# Initial Watershed Projects 2013 Annual Report

Initial Watershed Projects 2013 Annual Report  
Consent Decree Case No. 2:05-cv-00199-WOB

Re: Sanitation District No. 1 Watershed Plans  
Civil Action No. 2:05-CV-199-WOB

### Lakeview System Improvements Schedule

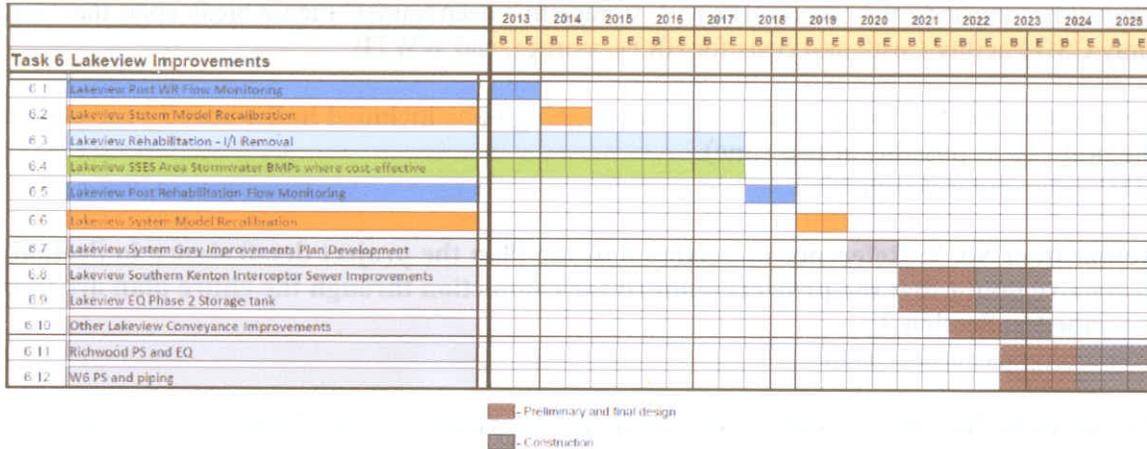
SD1's Action Item 4 response describes the ultimate elimination of SSOs at the Lakeview PS and includes the table on page 3 of SD1's responses (below) that indicates that final project completion for elimination of the Lakeview PS constructed overflow outfall is requested to be December 31, 2025, which coincides with the final compliance date of the Consent Decree to eliminate non-Exhibit E SSOs. However, the March 31, 2011 Watershed Plans indicate on Figure 8-2, page 8-7 that the Richwood PS and WS6 PS and associated projects are "facility planning<sup>1</sup>" projects not associated with the SSOs currently plaguing the system and therefore will not be considered as necessary projects needed to meet any regulatory deadlines to eliminate the SSO at the Lakeview PS. EPA and KDEP agree that a deadline of December 31, 2023 is reasonable for final elimination of the SSO located at the Lakeview PS.

Each Watershed Plan Update should re-evaluate whether the ultimate elimination of the SSO at the Lakeview PS can be eliminated sooner than December 31, 2023.
